# Access Compliance Report

## Public Rights-of-Way

### (Curb Ramps)

Intersection ID: 10035790	Main Street: REMOUNT_RD	Cross Street: N/A	Location: S
ADA ID: 4367EDE8CF99	Ramp Type: Perp	Initial Pass/Fail: Fail	Overall Compliance: No
		Severity Score: 12.5

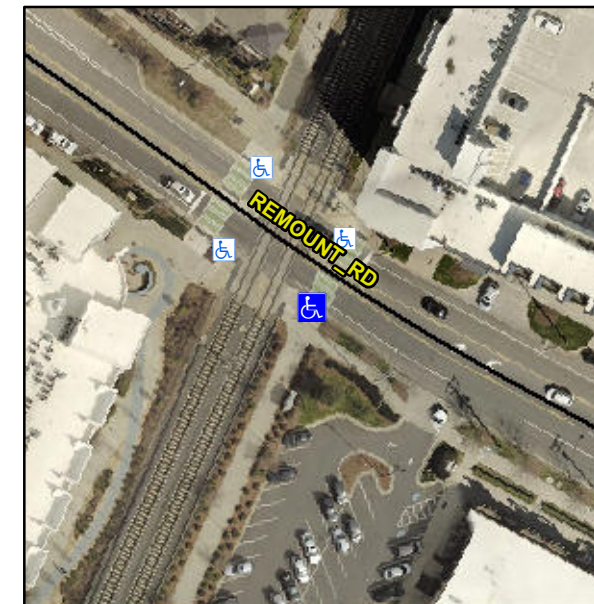
**Not Found, R304.5.3**

Compliance	Description	Data	Compliance	Description	Data
N/A	Ramp Length (in)	105.0	Yes	Ramp Slope (%)	6.8
Yes	Ramp Width (in)	148.0	No	Ramp XSlope (%)	5.4
N/A	Flare Type LT	N/A	N/A	Flare Type RT	N/A
N/A	Flare Slope LT (%)	N/A	N/A	Flare Slope RT (%)	N/A
N/A	Flare Traversable LT?	N/A	N/A	Flare Traversable RT?	N/A
N/A	Landing Length (in)	N/A	N/A	DWS Provided?	N/A
N/A	Landing Width (in)	N/A	N/A	DWS Contrast?	N/A
N/A	Landing Slope (%)	N/A	N/A	DWS Length (in)	N/A
N/A	Landing X Slope (%)	N/A	N/A	DWS Full Width?	N/A
N/A	Landing Curb? (Y/N)	N/A	N/A	DWS Offset (in)	N/A
N/A	Shared Landing?	N/A			
N/A	Gutter Ponding?	N/A	N/A	Gutter Slope (%)	N/A
N/A	Gutter Lip Ht (in)	N/A	N/A	Gutter X Slope (%)	N/A
N/A	Painted X Walk1?	Yes	N/A	Painted X Walk2?	N/A
	X Walk 1 Direction	To NE		X Walk 2 Direction	N/A
N/A	X Walk 1 Width (in)	137.0	N/A	X Walk 2 Width (in)	N/A
	X Walk 1 Slope (%)	1.6		X Walk 2 Slope (%)	N/A
	X Walk 1 X Slope (%)	2.3		X Walk 2 X Slope (%)	N/A

**Remove & Replace Entire Ramp.**
